Minutes of 2 nd Meeting of Technical Working Subgroup on Amendment 3 to GTR9	
Title	3 rd Meeting of Technical Working Subgroup on Amendment 3 to GTR9
Place	Teams
Status	Final
Meeting Date	03 December 2021, 6am-9am EDT / 12pm-3pm CET / 8pm-11pm JST
Prepared By	Benjamin Buenger (Audi), Oliver Zander (BAST)
Purpose of Meeting / Agenda	Discussion on Markup Methods and Test Point Methods for Headform Test Procedure in GTR9 Amendment 3
Issue date	13 December 2021
Next meeting	Not planned
Invited	Interested Experts from Contracting Parties to the 58 and the 98 Agreements, OEMs and Suppliers

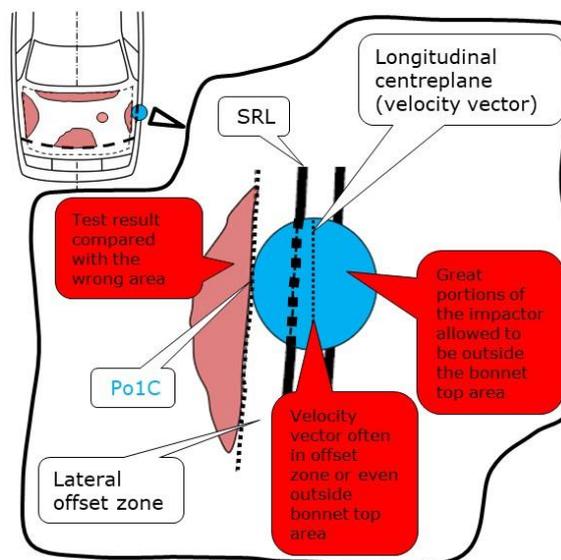
OZ presented a summary of the remaining discussions (TWSG-03-02) which were the common interpretation of the markup sequence and the permission to perform tests in the offset zones. He pointed out that marking the HIC 1,000 and HIC 1,700 zones prior to marking the WAD and 82.5mm offset lines would result in undefined shares of HIC 1,000 and 1,700 in the impact area with unnecessary forecasts in the offset zones:

He added that this would be significantly different to what has been always done in type approval testing. Both approaches however would be possible according to GTR9; a combination of both approaches however could not be interpreted from the wording of GTR9.

GTR9 – Examples of the „combined test area“

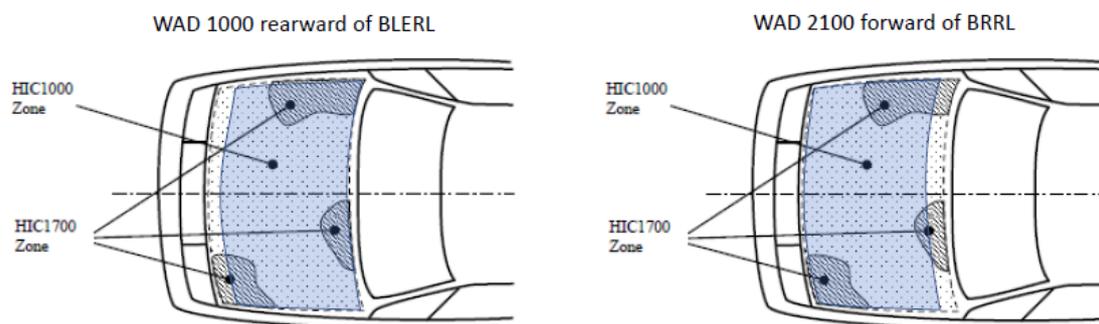
DG tried to clarify based on GTR No.9 text, showing where the lack of clarity may come from (TWSG-03-04). The combined test area and the bonnet top were not separated clear enough in the text:

The HIC recorded shall not exceed 1,000 over a minimum of one half of the child headform test area and 1,000 over two thirds of the combined child and adult headform test areas. The HIC for the remaining areas shall not exceed 1,700 for both headforms.

In every case there are parts of the HIC 1000 zone up to the test area borders!

Amendment 3 intended to clarify this aspect. There was no way of applying the whole area related to requirements in the offset area only. DG concluded that GTR 9 must be amended to ensure that the 1/3-2/3 requirement could be verified, i.e. that it was only related to the testable part of the impact area.

PB suggested that the proposed **amendment to paragraph 5.2.4.1** should solve the main problems the US were facing:

5.2.4.1. The manufacturer shall identify the zones of the bonnet top **test area** where the HIC must not exceed 1,000 (HIC1000 Zone) or 1,700 (HIC1700 Zone) (see Figure 11).

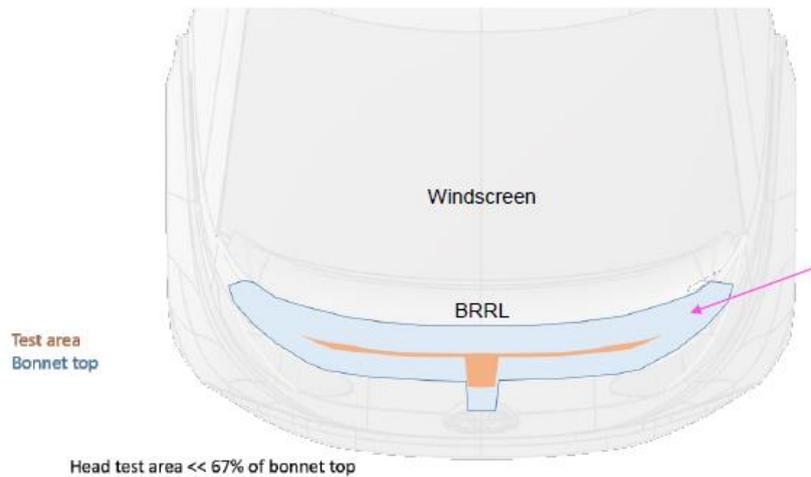
BB presented a study on how the offset areas are assessed in regulations today (TWSG-03-03). The data indicated that the offset area is interacting with the head impactor and is required to deform for the desired values of HIC for meeting the thresholds. Three examples for a clear deformation of the bonnet top in the offset zones - close to the side reference lines, the bonnet rear reference line and the WAD 1,000 line – while aligning the impactor according to the 2D method as described in Draft Amendment 3 were illustrated:

It was concluded that HIC values were directly related to deformation, i.e. that a reduction in safety by application of Draft Amendment 3 to GTR9 was not intended, nor happening, as the entire bonnet top area up to the borders was assessed. The formal assignment of performance to a single target was required for documentation, as well as validity of the performance claim. A target close to another impact point would show a different outcome in terms of HIC values, despite being in the same zone. So formally, if direct HIC values were documented, these could only be true for the very impact point. If just pass or fail was documented, then all the zones could be documented in a simplified way.
